City of Dublin

# Minor Project Review

## 14-018MPR – BSC Residential District

### 4353 Tuller Road, Suite E

**Proposed southwest elevation**

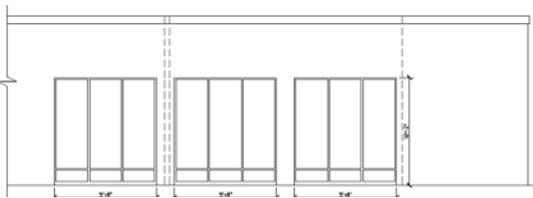
The proposed storefront windows differ slightly in that there is a muntin bar at the lower portion of the window, whereas the existing windows have a full pane of glass.

The addition of storefront systems to the southeast and southwest façades to replace the existing doors and square windows is consistent with the intent of the Bridge Street District building type requirements. Planning recommends that the pathway that leads to the existing door on the southwestern elevation be eliminated and that the curb be repaired in accordance with this modification, because the proposal will no longer include a door on this elevation. Planning also recommends that the applicant provide an ADA-compliant pathway to the new doorway entry on the southeastern elevation.

The applicant is proposing a storefront system with tempered glass inserted below the horizontal muntin, which differs slightly from the existing windows. Building has no objection to the proposed storefront window arrangement.

1. That the site plan be revised to remove the pathway leading to the existing door on the southwestern elevation, sod the remaining strip of land, and repair the curb section accordingly, and;
2. That the site plan be revised to include an ADA-compliant pathway to the proposed storefront door on the southeastern elevation.
